Access Compliance Report Public Rights-of-Way (Curb Ramps)

Main Street: LA_VETA_AVE Cross Street: SWIDLER_PL Location: SE

ADA ID: RPRK220222203131 Ramp Type: Type 1 - Perpendicular Diagonal Initial Pass/Fail: Fail Overall Compliance: No Severity Score: 16

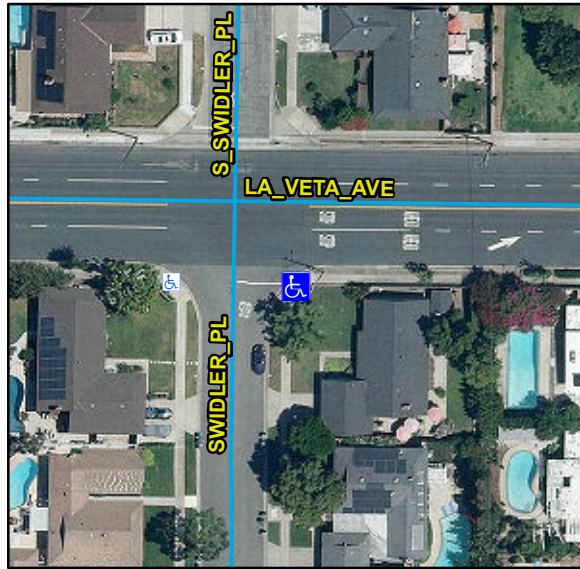
Compliance	Description	Data	Compliance	Description	Data
N/A	Ramp Length (in)	72	N/A	Flare Type LT	
Yes	Ramp Width (in)	48			N/A
No	Ramp Run Slope (%)	8.7	N/A	Flare Slope LT (%)	N/A
No	Ramp Cross Slope (%)	4	N/A	Flare Traversable LT	N/A
N/A	Landing Present	N/A	N/A	Flare Type RT	
N/A	Landing Length (in)	N/A			N/A
N/A	Landing Width (in)	N/A	N/A	Flare Slope RT (%)	N/A
N/A	Landing Run Slope (%)	N/A	N/A	Flare Traversable RT	N/A
N/A	Landing Cross Slope (%)	N/A	N/A	DWS Provided	N/A
N/A	Landing Movement Obstructed?	N/A	N/A	DWS Contrast	N/A
	Landing Movement Type	N/A	N/A	DWS Length (in)	N/A
N/A	Landing Shared	N/A	N/A	DWS Full Width	N/A
N/A	Clear Space	No	N/A	DWS Offset Left (in)	N/A
N/A	Clear Space To Crosswalk (in)	N/A	N/A	DWS Offset Right (in)	N/A
N/A	Marked Crosswalk 1	No	N/A	Marked Crosswalk 2	No
	Crossing 1 Direction	N		Crossing 2 Direction	W
	Marked Crosswalk 1 Width (in)	N/A		Marked Crosswalk 2 Width (in)	N/A

N/A	Ramp Inside Crosswalk 1	N/A	Yes	Ramp Inside Crosswalk 2	N/A
	Crossing 1 Slope (%)	6.4		Crossing 2 Slope (%)	4.4
	Crossing 1 Cross Slope (%)	5		Crossing 2 Cross Slope (%)	1.2
N/A	Gutter Ponding	N/A	N/A	Curb Slope	2.3
No	Gutter Lip Height (in)	2.3		Road Run Slope (%)	4.2
N/A	Gutter Run Slope (%)	N/A		Road Cross Slope (%)	7.1
N/A	Gutter Cross Slope (%)	N/A			
Yes	Overall Surface Condition: Acceptable		Yes	Perp Joint Present	Yes
	Cross Gutter Present?	No		Spandrel Present?	No
	Replace Cross Gutter?	N/A		Replace Spandrel?	N/A

Remove & Replace Curb Ramp With Two New Directional Ramps or Equivalent. Grind Gutter Lip.

R304.2.2, R304.5.3, R302.7.2, STD 1115
